Rezoning Transportation Analysis

Petition Number: 2024-143

Revision Log:	Date	Description
	1/22/25	First Review (CJM)
	2/19/25	Second Review (CJM)
	9/24/25	Third Review (CJM)
	10/23/25	Fourth Review (CJM)
	12/23/25	Fifth Review (CJM)
	01/22/26	Sixth Review (CJM)

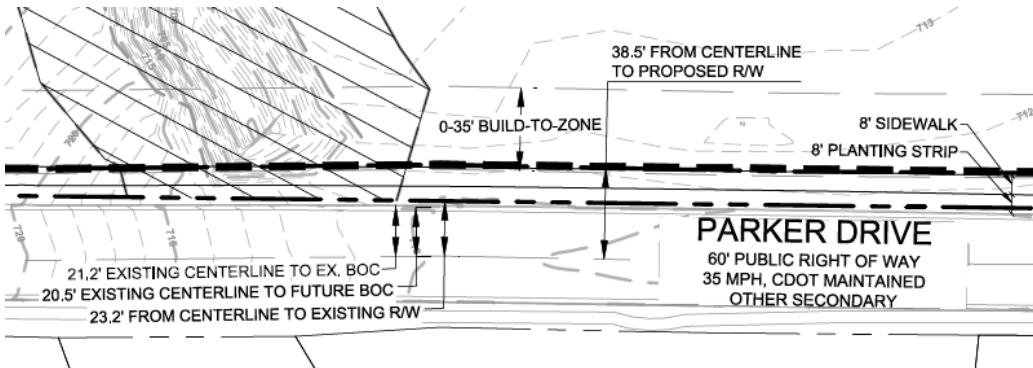
Curbline:

a. **Remount Road:** ~~Location of future back of curb and gutter to be installed 27' from centerline.~~

b. **Parker Drive:** ~~Location of future back of curb and gutter to be installed 20.5' from centerline.~~

c. **Berryhill Road:** ~~Location of future back of curb and gutter to be installed 20.5' from centerline.~~

~~Label and dimension the curb and gutter from the centerline for each road on the site plan.~~
